Name: Mini-Storage Units – 610 West Gunnison Avenue – Site Plan Review

REVIEW COMMENTS

FILE #10-94

TITLE HEADING: Site Plan Review - Mini Storage
Units

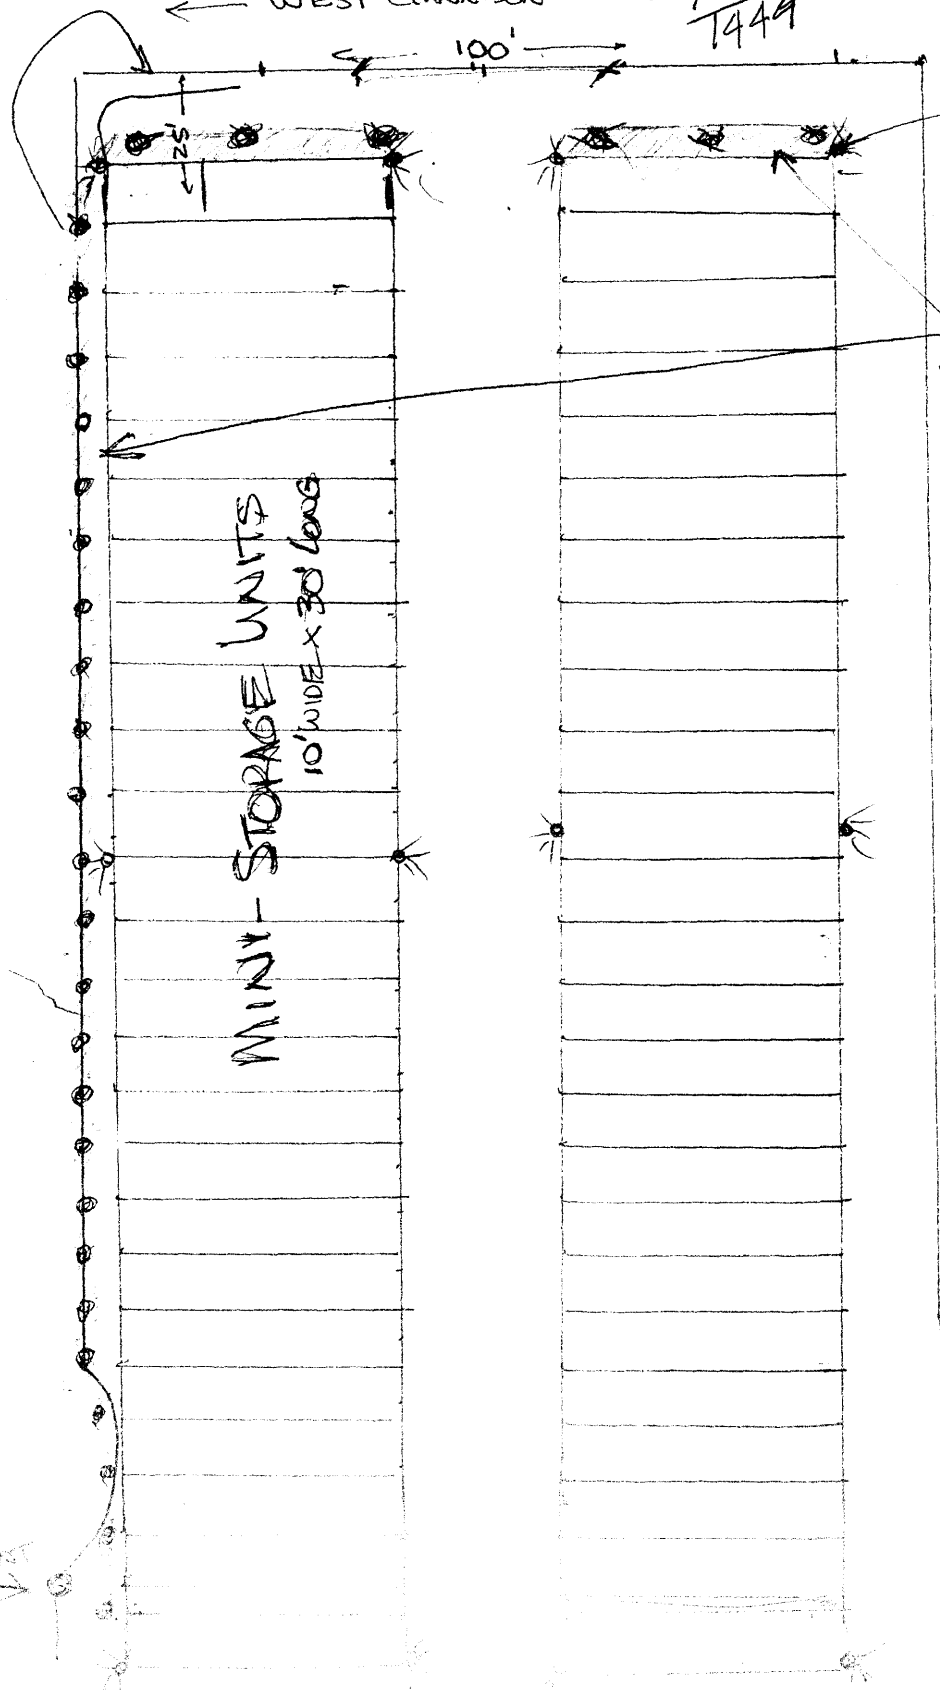
Fire-walls are required based on location on property and area of buildings. ALL plans (foundation, floor and structure) must be certified by an engineer or architect.

1. For final approval, the site plan and grading plan should be submitted following the criteria in the attached checklists, particularly the items circled in red.
2. The drainage fee is an option here, as long as the site is graded so it drains into the streets and not onto private property. I will need square footage of the buildings, paving and landscaping to calculate the fee.
3. The site plan should indicate there is sufficient area for moving trucks to maneuver on-site and get around the buildings. The public street may not be used for customer loading/unloading.
4. The existing curb cut should be noted on the plans, and whether or not is intended to be used. If it is being moved or modified, a City permit from the Engineering office will be required.

5. The site plan and grading plan should indicate the surfacing on-site - asphalt, concrete or other.

1. Lots 1 and 2 must be combined into a single tax parcel. Contact the Mesa County Assessors office for information on this process. Documentation that this has been done must be provided prior to issuance of a Planning Clearance for a building permit. This may eliminate the need for fire-walls (see Building Department comments and contact Bob Lee).

2. Drawing must be to scale and location and dimensions of aisles, landscaped areas, and driveways noted.
3. Show intended circulation pattern (i.e. is it only 1 way on the south side - not wide enough for 2 way?). Fire Department may require a minimum of 20 feet for access around the buildings.

4. Indicate on plan that northerly units will not be accessed from the north side - doors will be on south side. Indicate that southerly units will have doors on both sides.

5. How many total storage units?
6. The landscape requirement for this site is 1,444 square feet. Per the Zoning and Development Code (see attached), this will require 3 trees and 40 percent of the landscaped area shall contain shrubs. Minimum plant sizes are included in the attached. Any plants that die or are unhealthy shall be replaced.

Provide a more detailed landscape plan (may be on site plan) that indicates number, species, planting size, and spacing of plants. Also note that the landscaping will be irrigated with an underground, pressurized system as required by Code. Show the source of water for irrigation.

7. Will the development be fenced? If so, show location of fence and gate(s) and describe its height and material. If not, how will the hours of operation (8-5) be controlled.

1. Adequate access must be provided and indicated on an approved site plan shown to scale.
2. A fire flow survey must be conducted to determine the required flows. Submit a complete stamped set of building plans, to include a site plan for our review.

1. Is there going to be a chain link fence surrounding the storage sheds? If not, I would recommend one; minimum 6' chain link; for more security 2 strands of barbed wire extending out along top.
2. What would the distance be between the fence and building? How would the gate open? What is the distance between buildings and from the sidewalks and roadway?
3. Are the sensor lights motion sensor or are they the type that came on at dark? I would recommend ones that are on all the time at night.
4. What type of latches are going to be used on the storage doors? Are you going to offer padlocks to the owners and if so, what type?

Final plan
8/2/94

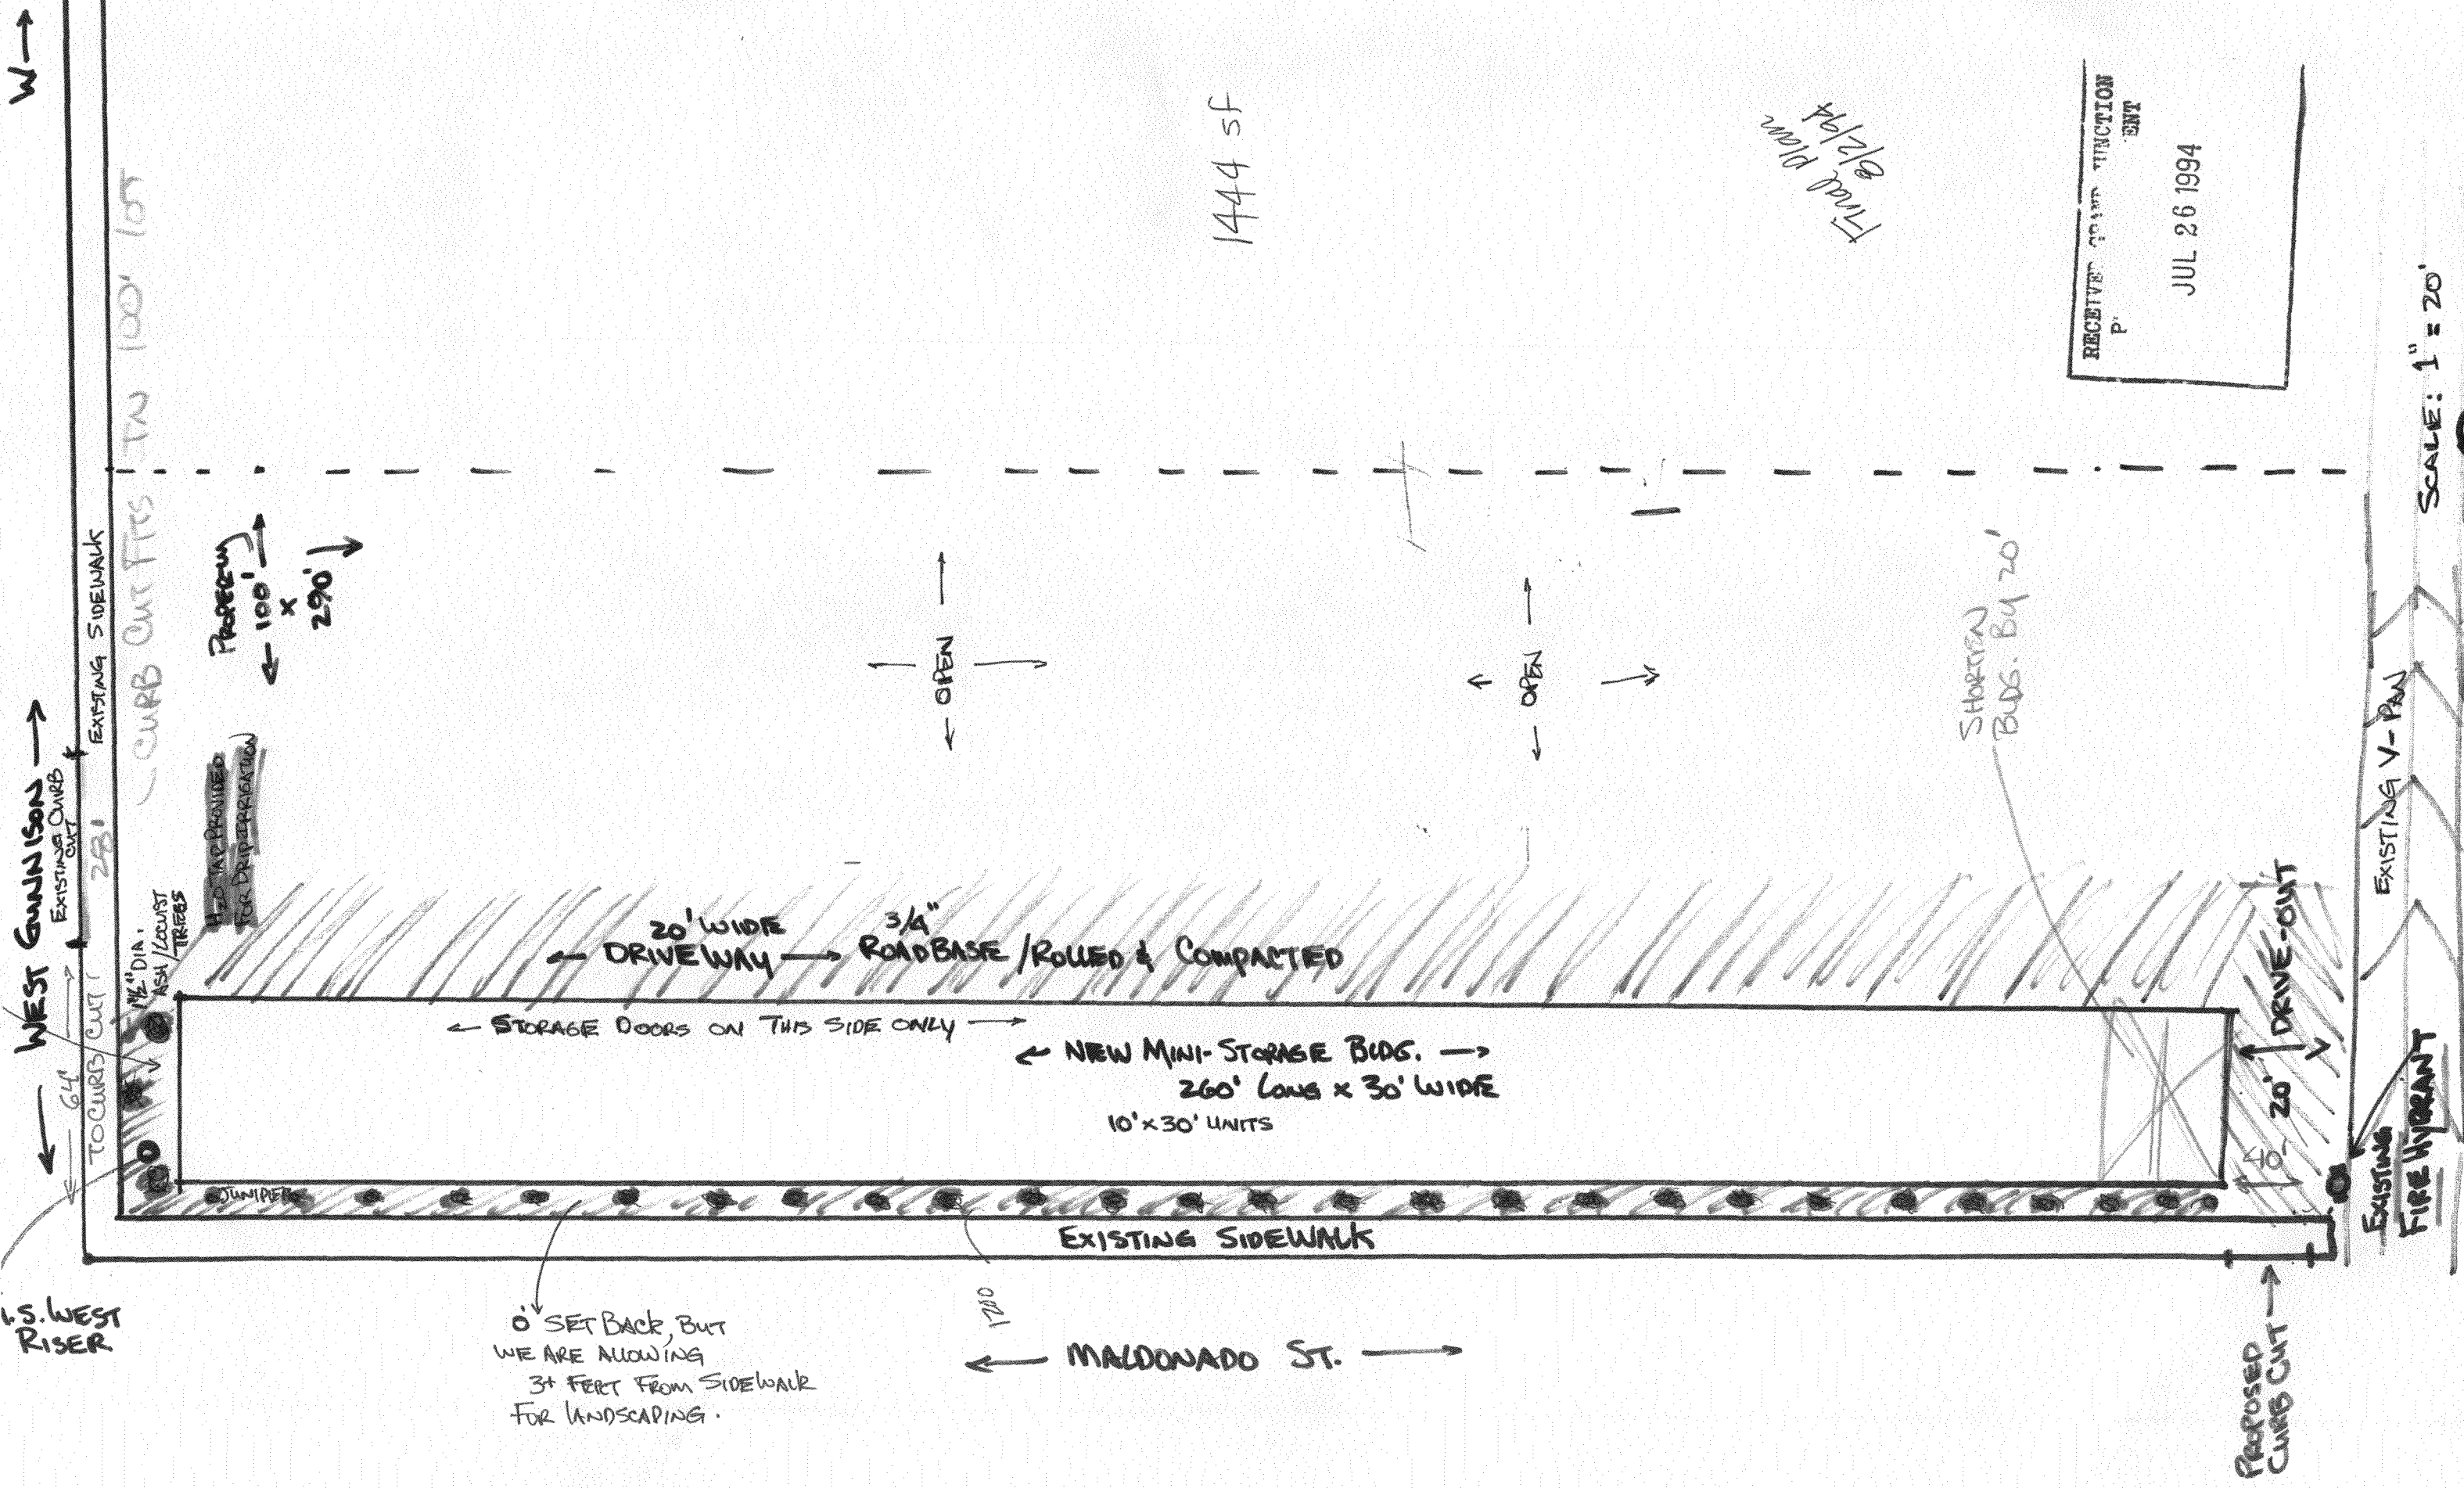
SHORTEN BLDG. BY 20'

H2O TAP PROVIDED FOR DRIP IRRIGATION

20' WIDE DRIVEWAY → 3/4" ROADBASE / ROLLED & COMPACTED

← STORAGE DOORS ON THIS SIDE ONLY →
